Proj. No.: RA 140 DESIGN, BUILD, COMPLETE AND MAINTAIN SHEIKH JABER AL-AHMAD AL-SABAH CAUSEWAY PROJECT (MAIN LINK)	Employer: STATE OF KUWAIT MINISTRY OF PUBLIC WORKS	Request No. RA140-HDC-22-CBR- DRW-0025-03
Engineer's Representative:  dar al-handasah engineer and partners  SSH  TYLIN INTERNATIONAL	Contractor:  HYUNDAI ENGINEERING & CONSTRUCTION CO. LTD.	Date 13/02/2016

Transmittal of Design Drawing

Detailed Design - Main Bridge Pile Cap of Pylon Drawing Package

Comment & Response Sheet

DRAWING NO.
RA140-22-BRG-CW-DW-32262

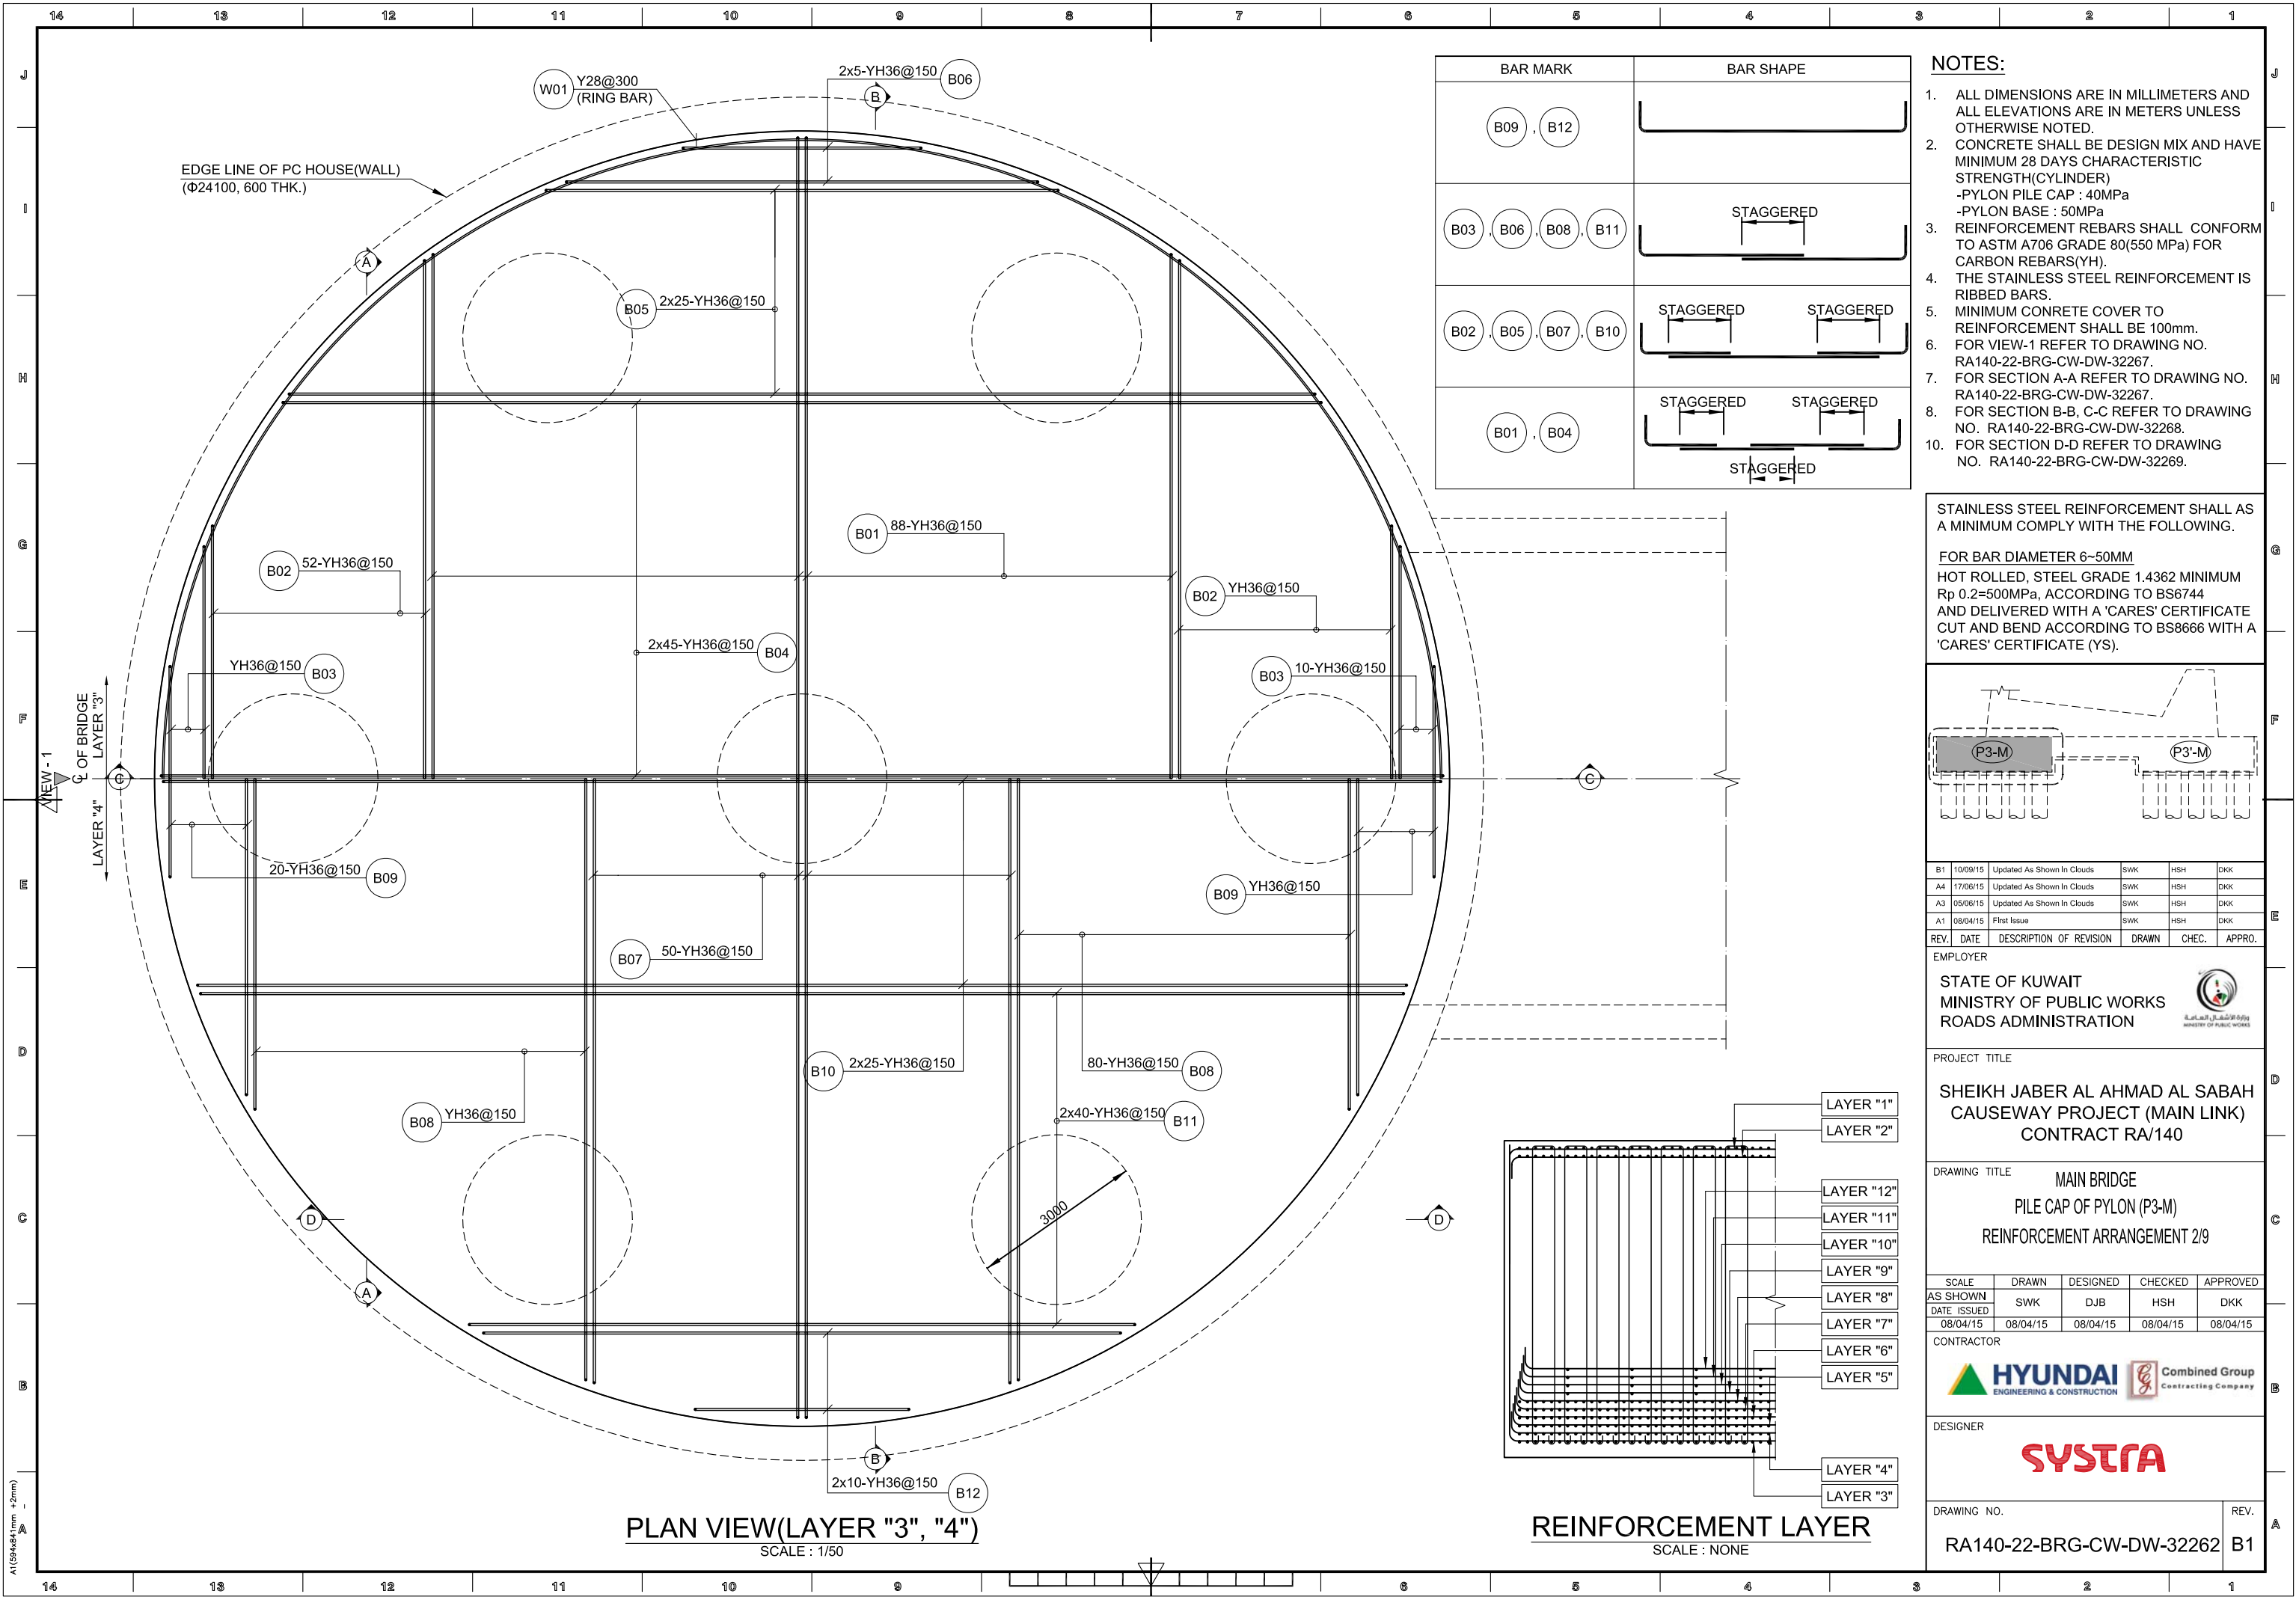
No.	Rev.	Reference		Comment rev. ²	Comment	Response	Cat. ¹	Status ³
1	A4	32262	Plan View ("3", "4")	1 st comment	Layers 3 through 12 need to include a detailed study of the conflict resolution between the bottom mats of steel and the pile bars. Please add additional details.	The bottom mats of steel (Layer 3~12) will be arranged in order to avoid the clash with the pile bars as shown in the drawing, RA140-22-BRG-CW-DW-32278. Please refer to the Appendix #1. Based on the scheme drawing, we will prepare and submit a construction drawing.	2	
				2 nd comment	The solution of high precision bending of bars to match an as-built condition in the field seems overly optimistic. It is recommended to provide a solution which has a higher degree of tolerance for field adjustments.	As-built condition in the field must be different with the design, so any solutions at design stage may not satisfy the site condition perfectly. We will process rebars with bending machine on site using actually surveyed results.		BB

B1			3 rd comment	Any significant field modifications to reinforcement steel to resolve conflicts must be reviewed and approved by the Designer for compliance with the design. If modifications result in changes to the design, the changes must also be reviewed and approved by the ICE.	Noted. The change of reinforcement arrangement to resolve conflict or adjust to the field condition, requested by Contractor has been reviewed and approved by Designer and ICE.		BB
				4 th comment	Please provide documentation of the reviews by Designer and ICE.			BB

DRAWING NO.
RA140-22-BRG-CW-DW-32278
REV.
B1

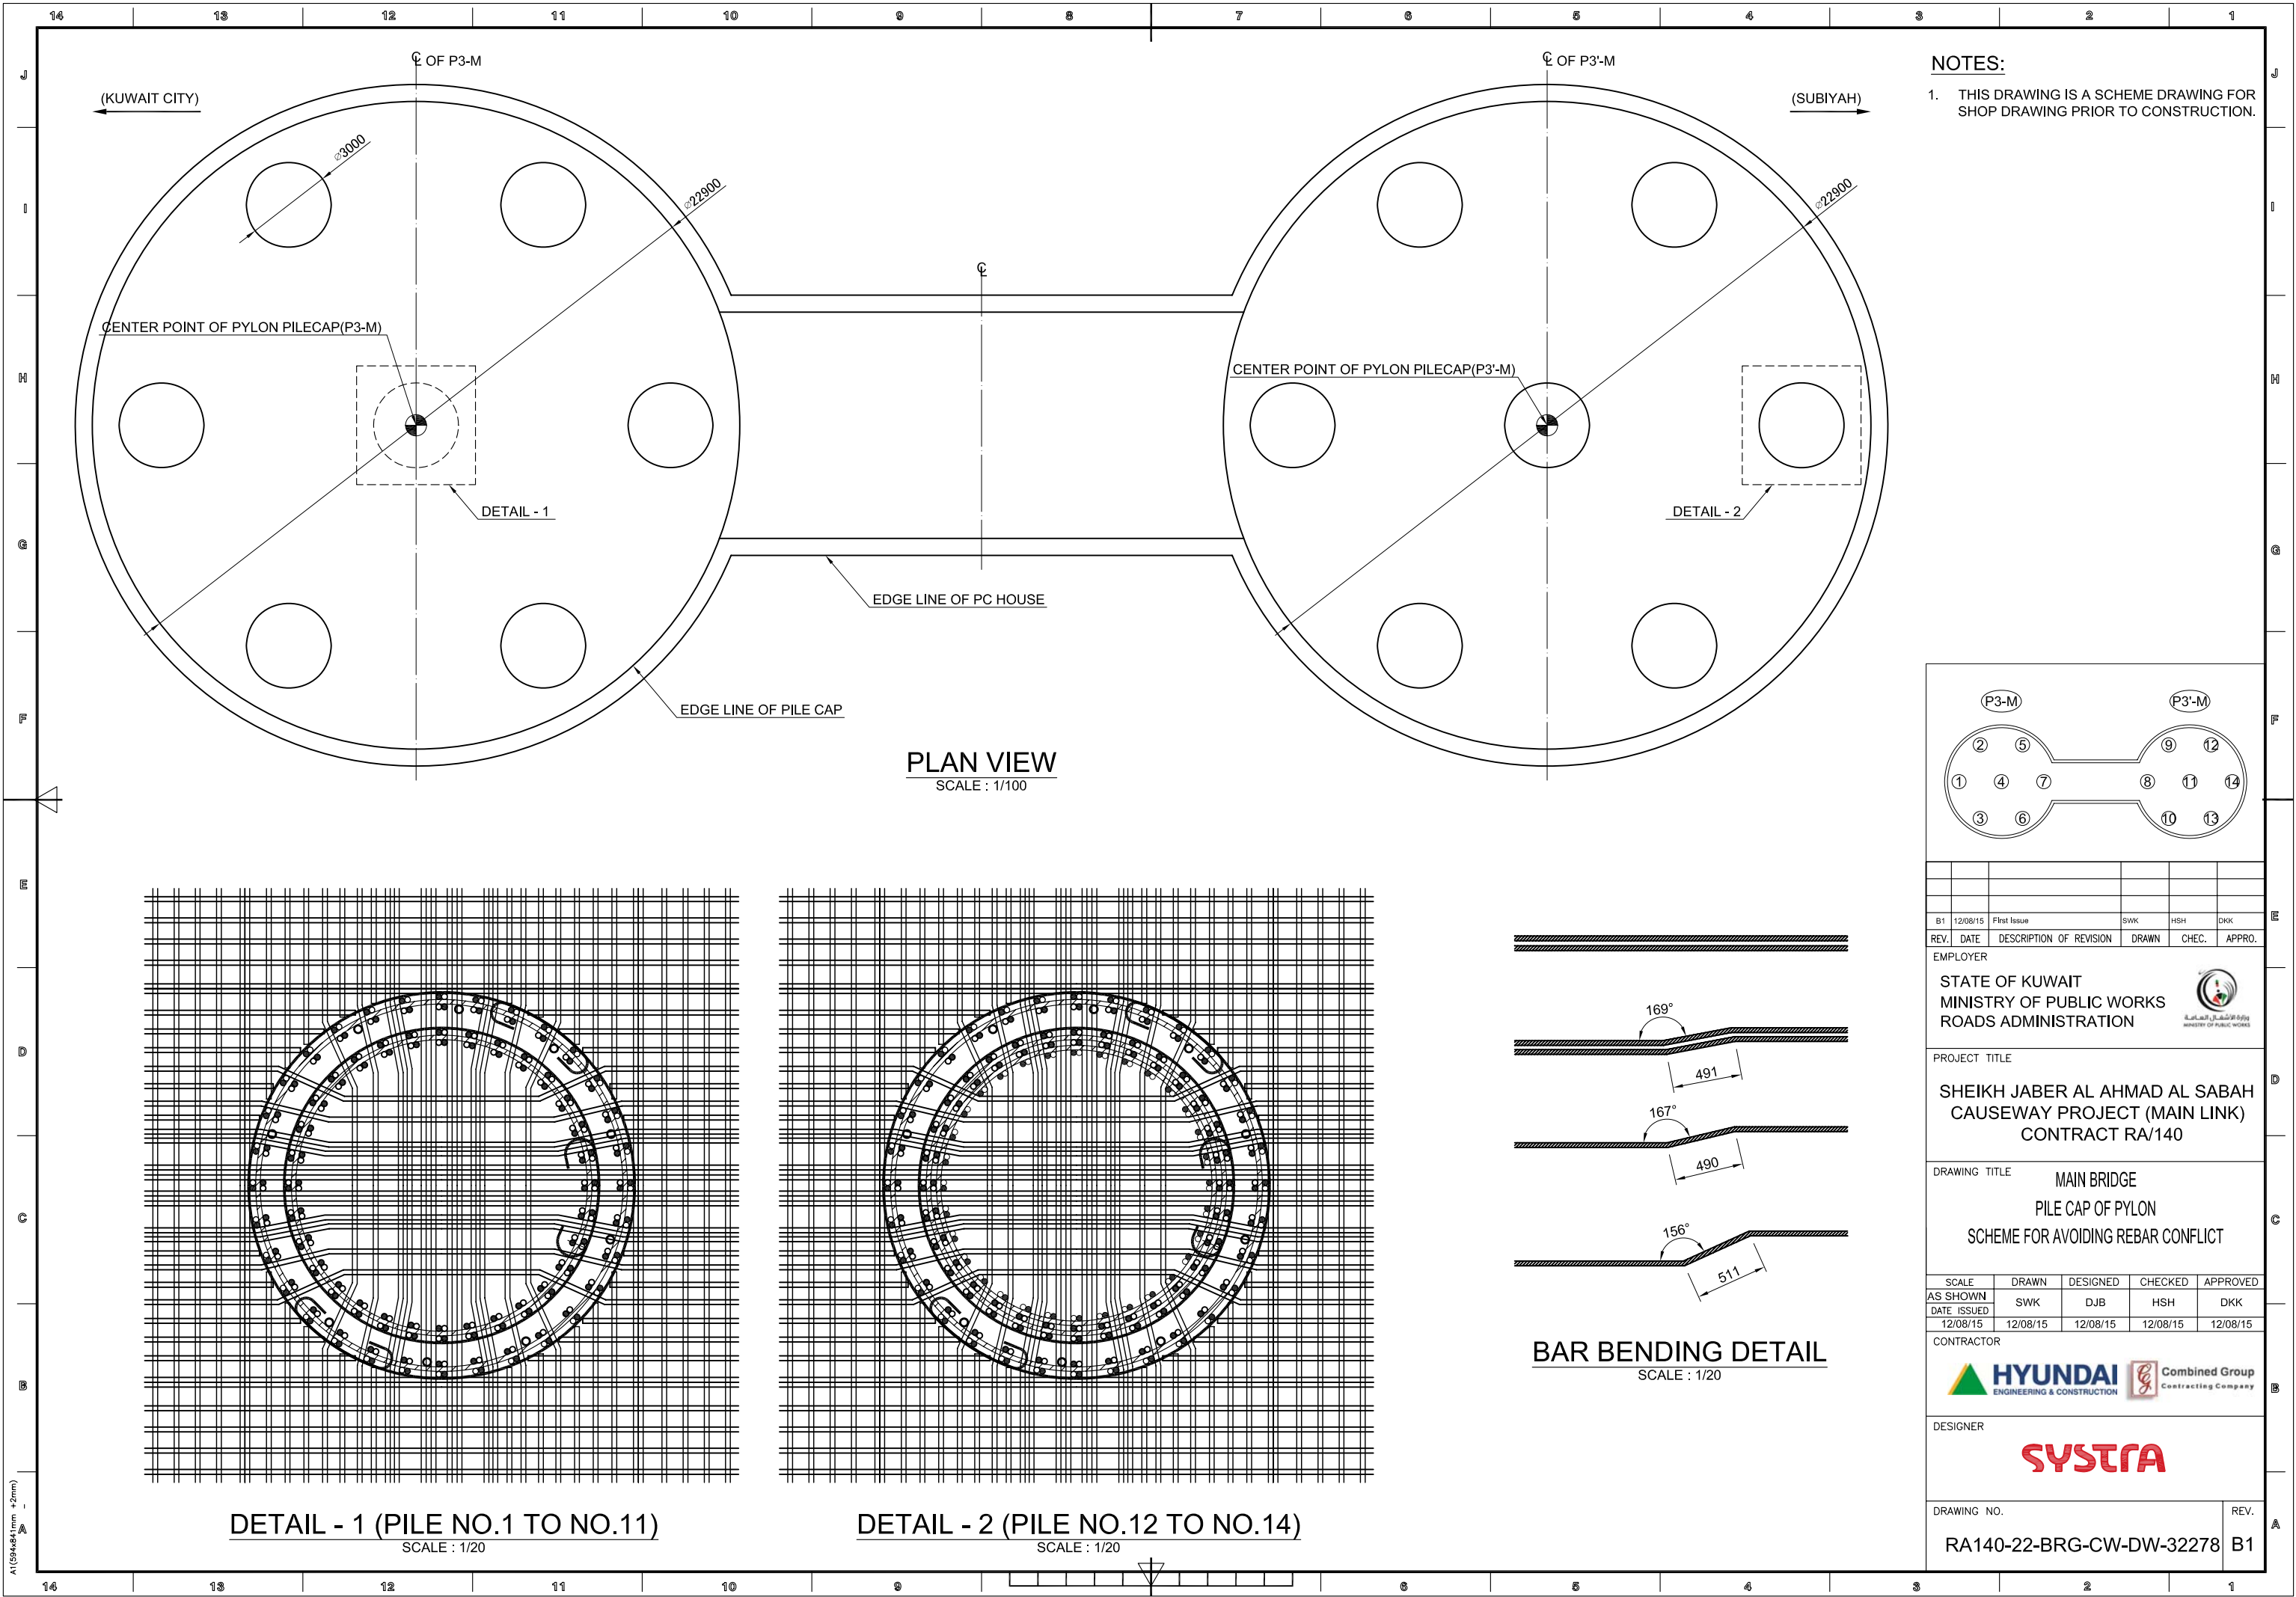
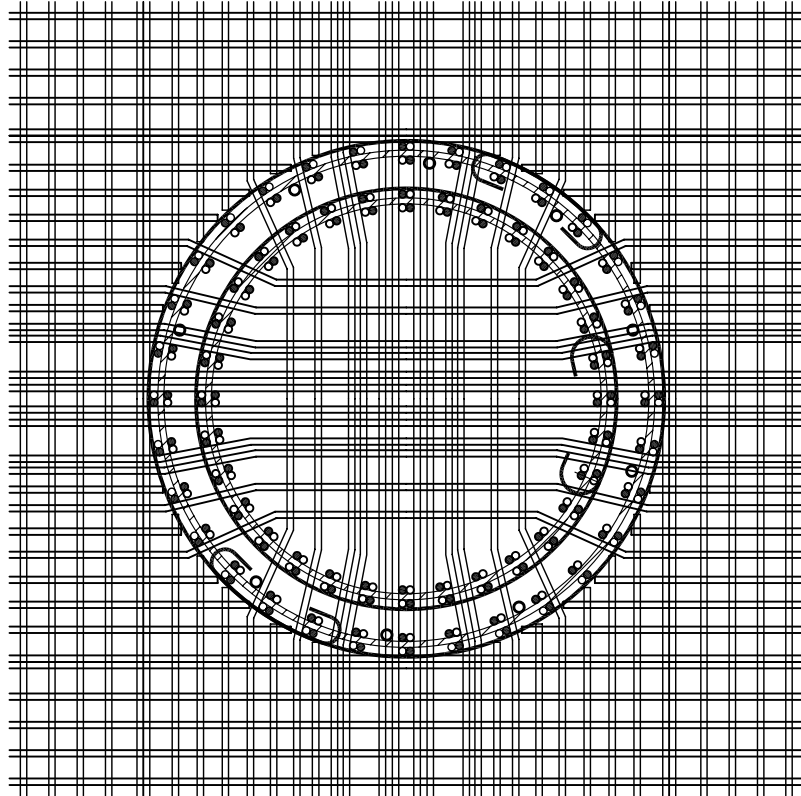
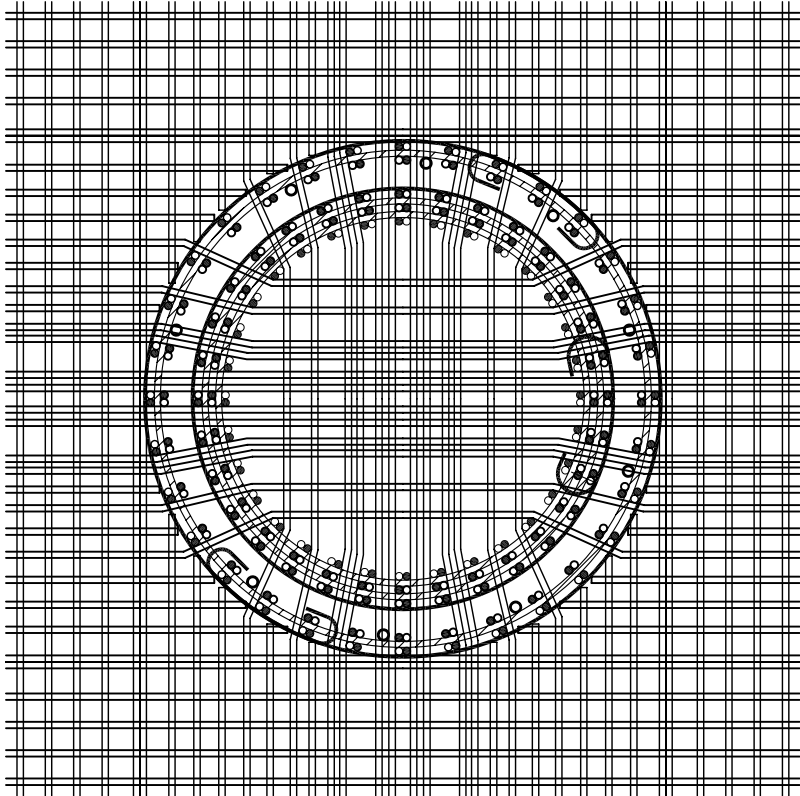
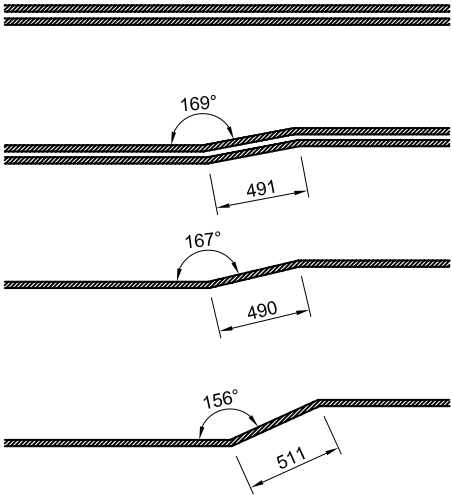
3	A4	32268	Section C-C	1 st comment	Layers 3 through 12 are not developed at the face of pile. Add hooks or heads.	Hooks will be added to the Layer 8~12 without hooks at the face of the pile as commented. Please refer to the Appendix #2.	2	
				2 nd comment	The detail is incomplete. The pile cap is circular and as such the transverse bars will not be placed as shown. They will be terminating and bent up along the same face as the longitudinal bars. The resolution must be a 3D solution which resolves conflicts with all the mats of steel.	Please refer to our answer to comment #2.		CC
	B2			3 rd comment	Refer to comment #2.	This has been developed in shop drawings.		AA
4	A4	32276	Section B-B	1 st comment	Include a detailed study of the conflict resolution between the bottom mats of tie beam steel and the pile bars. Please add additional details.	Based on the scheme drawing of RA140-22-BRG-CW-DW-DW-32278, we will prepare and submit a construction drawing.	2

2 nd comment	The solution of high precision bending of bars to match an as-built condition in the field seems overly optimistic. It is recommended to provide a solution which has a higher degree of tolerance for field adjustments.	Please refer to our answer to comment #1.		BB
	B2			3 rd comment	Refer to comment #1.	Noted. The change of reinforcement arrangement to resolve conflict or adjust to the field condition, requested by Contractor has been reviewed and approved by Designer and ICE.		AA
5	A4	32282	View-1	1 st comment	Top and bottom tie beam bars are not developed beyond the point where they are no longer needed. Please extend the bars farther into the pile cap section.	The top and the bottom beam bars are extended to secure required development length. Please refer to the Attachment #3.	2	
				2 nd comment	These bars are very long and will require mechanical couplers. Please revise the drawings to show the location of the	The length of the PT bars which conflict with tie beam bars will be reduced to 9.7m from 10.0m to avoid the rebar crash.		CC
